June 14, 2010

**Re: ISO New England Inc. and New England Power Pool Participants Committee,  
Docket No. ER10-882-000; Responses to Deficiency Letter**

ISO New England Inc. (the “ISO”) provides the following responses to the questions posed by the Federal Energy Regulatory Commission (“FERC” or “Commission”) in the deficiency letter issued on May 14, 2010 in the above-referenced docket. The Commission’s questions address a proposal to revise the Forward Capacity Market (“FCM”) rules<sup>1</sup> to include an overlapping interconnection impacts analysis for each new active Demand Resource<sup>2</sup> that seeks to participate in the Forward Capacity Auction (“FCA”). The ISO appreciates the opportunity to answer these questions.

**Figure 1 - Overlapping Interconnection Impacts Graphic Example**

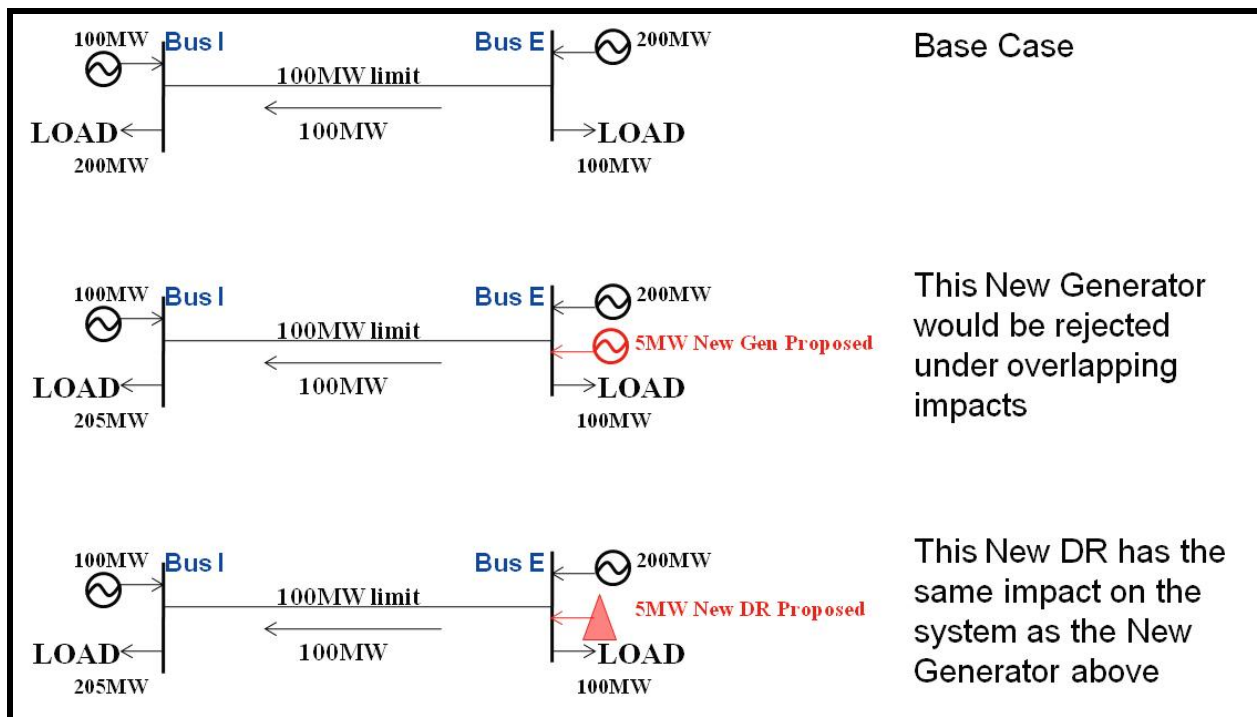
**1. Please explain any reliability impacts that would arise if the proposed FCM rules change is not implemented.**

If the proposed FCM rule changes are not implemented, there will be a negative impact on the reliability of the system because new active Demand Resources that cannot provide incremental capacity that can be counted toward meeting the ICR will qualify for the FCA. In other words, if some of the capacity that is procured through the FCA (*i.e.* capacity procured from new active Demand Resources) is not deliverable to serve load, then the ICR will not be met. The example shown in Figure 1 below illustrates this concern.

The example consists of a simple two-bus power system connected by a transmission line with 100 MW of transmission transfer capability. For this example, we will assume that the transmission line cannot be upgraded in time for the Capacity Commitment Period of concern. We can think of the two-bus system as a simplified representation of the distribution of load within a Load Zone, with a transmission constraint within that Load Zone. In the base case, on one side of the transmission constraint, 200 MW of load is connected along with 100 MW of generation. This first bus has more load than generation and power is imported to the bus over the transmission line. We will call this bus “Bus I” – an importing bus. On the other side of the constraint is a bus with 100 MW of load and 200 MW of generation. This bus has more generation than load and power is exported away from the bus over the transmission line. We will call this bus “Bus E” – an exporting bus. In the base case, the excess generation at Bus E can be transferred to the excess load at Bus I over the transmission line. As shown in Figure 1, in the base case, the load can be reliably served.

Next, suppose that load has grown and 5 MW of additional load has been added to what was the 200 MW load at Bus I. No more power can be transferred over the transmission line, so any additional generation on the opposite end of the line at Bus E cannot be delivered to this incremental load. For this reason, a new 5 MW generator proposed on the exporting side of the constraint (at

Bus E) would be disqualified as a result of overlapping interconnection impacts. That is, when the new generator is added to the base case that includes the existing generators, the new generator is not deliverable to the load.

Finally, consider a proposed new Demand Resource comprising a load reduction measure of 5 MW at the same exporting bus (Bus E). With the demand reduction, the net load at Bus E is now 95 MW and with the existing generation of 200 MW at Bus E we would have a net export of 105 MW, which of course could not be accommodated by the transmission line. In other words, this proposed new demand reduction of 5 MW at Bus E has an identical impact on the transmission line as the proposed new 5 MW generator at Bus E. That is, when the new Demand Resource is added to the base case that includes the existing resources, the new Demand Resource is not deliverable to the load at Bus I.

Although this is a very simplified example, the principle applies to real world power systems. Certain reductions in load, depending on the location of the reduction, do not provide an overall benefit to the system because of transmission constraints. This is the essence of the reliability concern that is behind the proposal to add an overlapping interconnection impacts analysis for new active Demand Resources. In short, adding new active Demand Resources at a location that is already export-constrained will negatively impact reliability because these resources will constitute a part of the ICR that is purchased, but will not be able to serve load. This will mean that
